ALERT SERVICE BULLETIN

212-23-168

MODEL AFFECTED: 212

SUBJECT: TENSION ROD ASSEMBLY P/N 212-030-170-007, INSPECTION OF.

Figure 6. Rework requirements

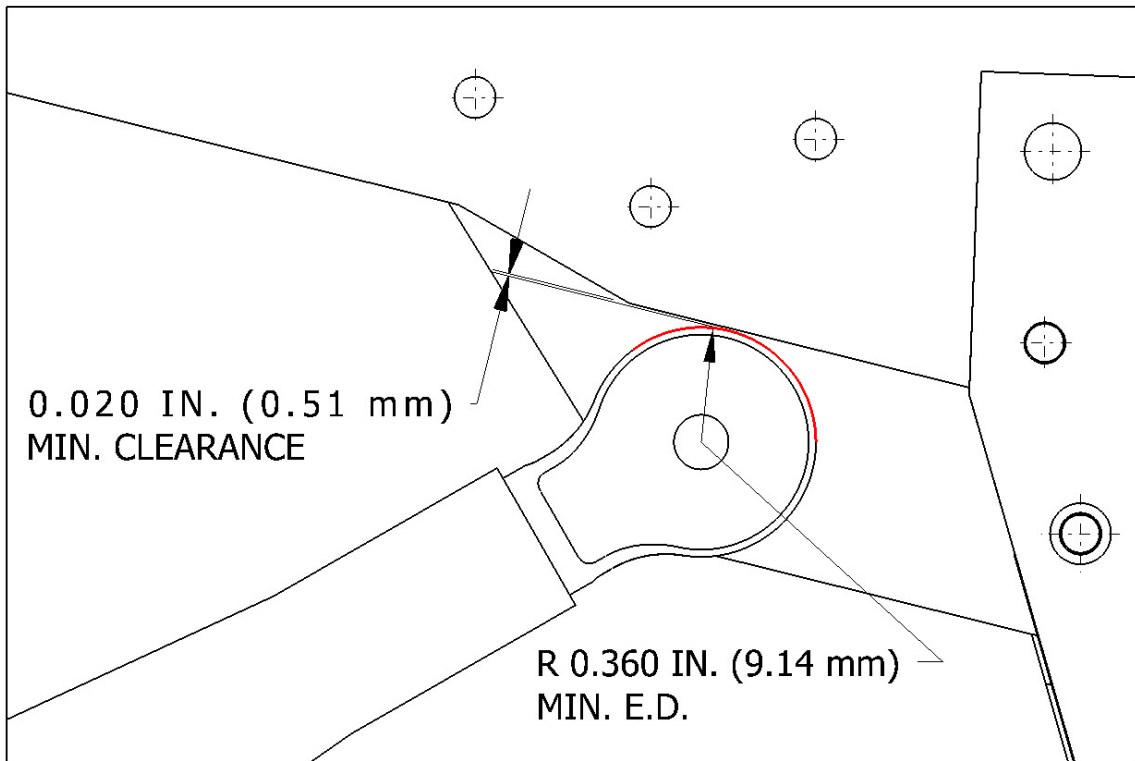
It is acceptable to remove material from the rod ends and/or the structure attachment locations to comply with inspection criteria defined in **PART I** (Figures 4,5 and 6).

It is acceptable to remove material from the rod ends and/or the structure attachment fitting provided the inspection criteria defined in **PART I** are respected (Figures 4,5 and 6).

4. Remove the tension rod assembly.
5. Trim and deburr previously marked material on the affected rod end and/or structure attachment fitting. Ensure the inspection criteria defined in **PART I** are respected (Figures 4,5 and 6).

LOOKING INBOARD ON UPPER ATTACHMENT
Figure 1. Inspection requirements

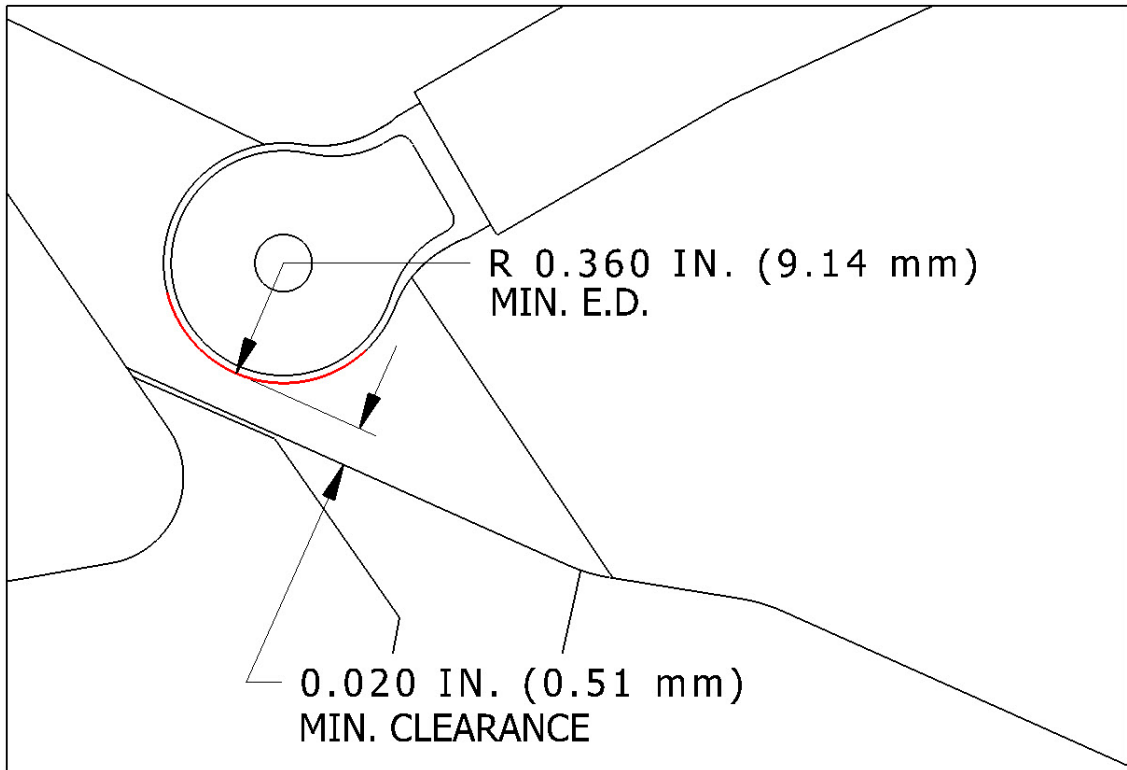
2. Inspect the forward end (upper attachment location) of the tension rod assembly as follows:
 - a. Inspect the outboard side of the tension rod assembly rod end for a possible over trimmed condition. Minimum acceptable radius dimension measured from the bolt hole center is 0.360 inch (9.14 mm) edge distance (E.D.) (Figure 1). Removal of the attachment bolt may be required to perform this measurement. Record findings.
 - b. Check for fouling or low clearance conditions between the rod end and the structure (cap, web, angle). Minimum acceptable clearance is 0.020 inch (0.51 mm) (Figure 1). Record findings.

4. Following the inspections performed in steps 2 and 3, accomplish one of the following actions:
 - a. If no over trimmed conditions were found and there are no low clearance or fouling conditions, make an entry in the helicopter logbook and historical service records indicating findings and compliance with this Alert Service Bulletin.
 - b. If one or both rod ends have been over trimmed, accomplish **PART II**.
 - c. If no over trim conditions were found but there is a fouling or a low clearance condition, accomplish **PART III**.

Figure 2. Inspection requirements

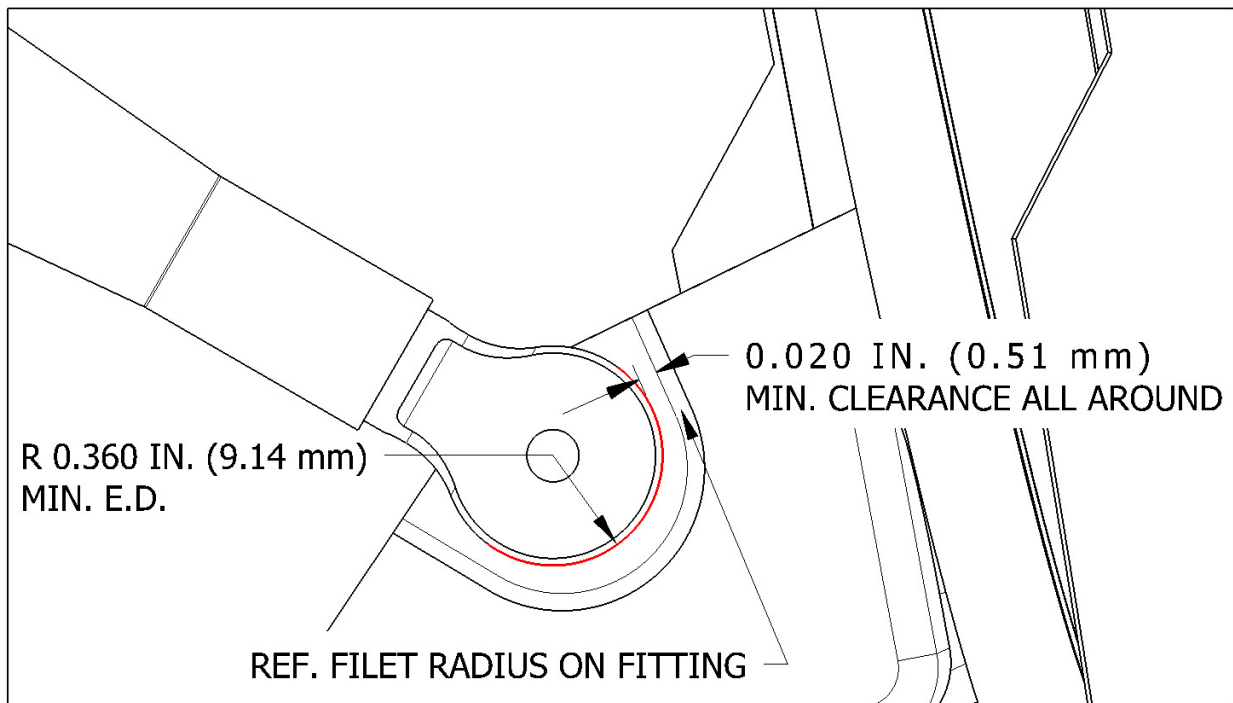
3. Inspect the aft end (lower attachment location) of the tension rod assembly as follows:
 - a. Inspect both sides of the tension rod assembly rod end for a possible over trimmed condition. Minimum acceptable radius dimension measured from the bolt hole center is 0.360 inch (9.14 mm) edge distance (E.D.) (Figure 2 and 3). Removal of the attachment bolt may be required to perform this measurement. Record findings.
 - b. Check for fouling or low clearance conditions between the rod end and the structure (cap, web) on the outboard side and the fillet radius on the inboard side of the fitting. Minimum acceptable clearance is 0.020 inch (0.51 mm) (Figures 2 and 3). Record findings.

Figure 7. Tension rod assembly proper installation verification

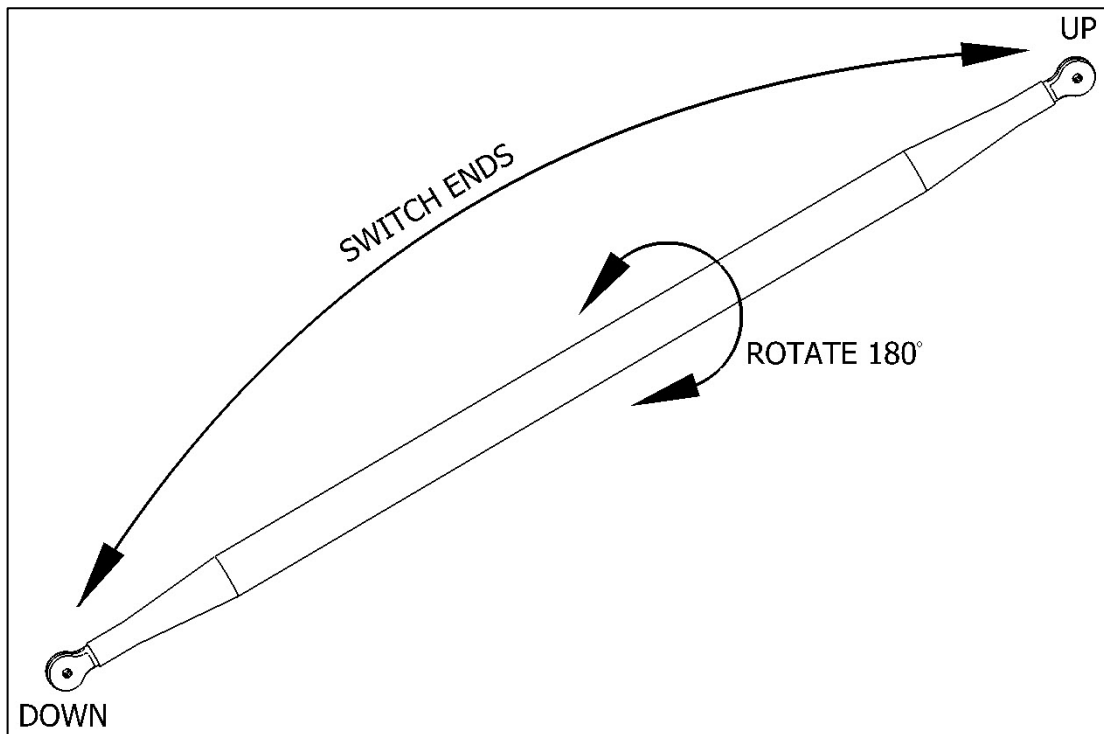
1. If a fouling or a low clearance condition exist, the tension rod assembly may have been installed incorrectly. Prior to trimming the rod ends, remove the tension rod assembly and try different orientations by rotating and/or switching ends to obtain the best possible fit (Figure 7). If proper clearance dimensions as defined in **PART I** cannot be meet, proceed with step 3.
2. If it is established that the root cause for the fouling or low clearance condition is the incorrect installation of the tension rod assembly, reinstall correctly and proceed with step 8.

Figure 8. Work aid detail.

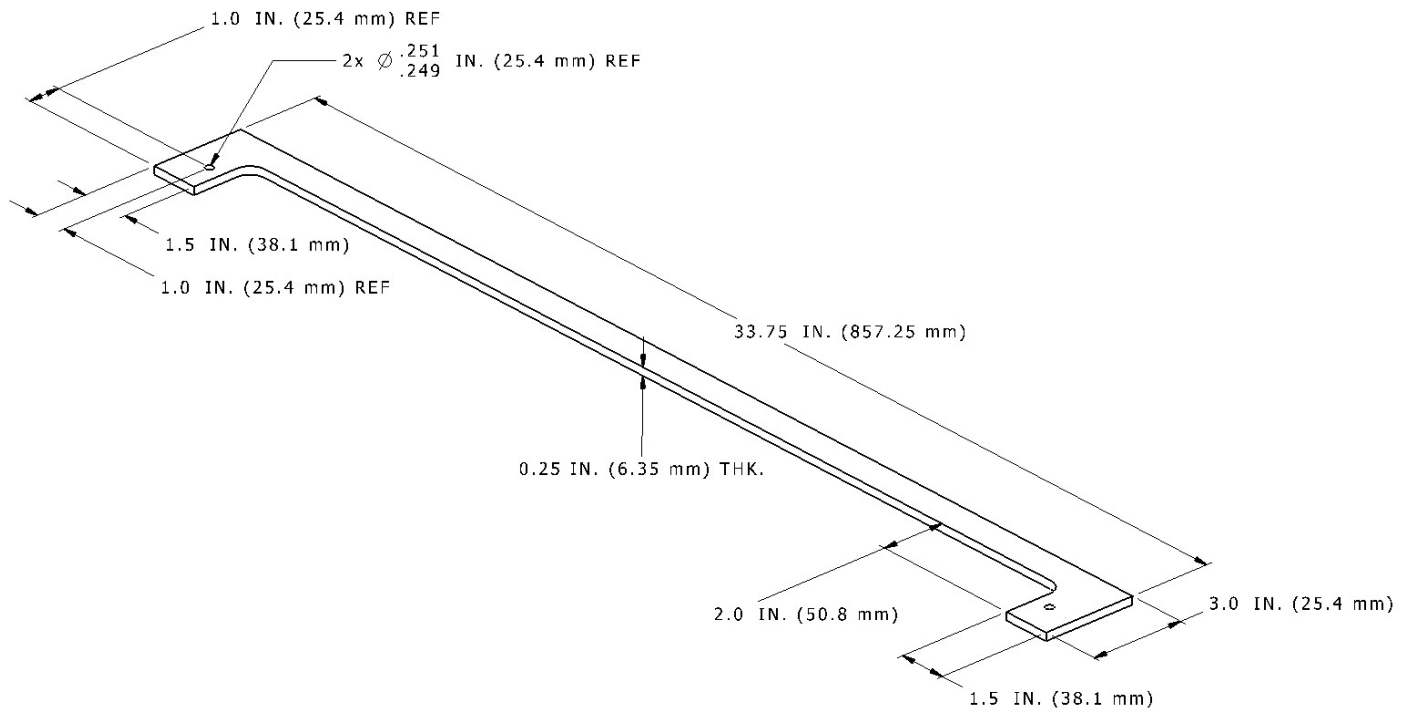
2. Using the information from Figure 8 as a guide, fabricate a work aid that can precisely locate the holes on the new tension rod assembly. The work aid material is at the discretion of the operator.
 - a. Transfer 0.249 to 0.251 inch (6.32 to 6.38 mm) diameter holes from the removed tension rod assembly to the work aid (Figure 8 and 9).

- b. Drill the two 0.249 to 0.251 inch (6.32 to 6.38 mm) diameter holes 2x in the rod ends of the piloted tension rod assembly from the work aid (Figure 8 and 9).
3. Install the new tension rod assembly, do a fit check, and mark the minimum material removal required on both rod ends and/or on the structure at the required locations to obtain the required clearance.
 4. Trim and deburr previously marked material on the affected rod end and/or structure. Ensure the inspection criteria defined in **PART I** are respected (Figures 4,5 and 6).
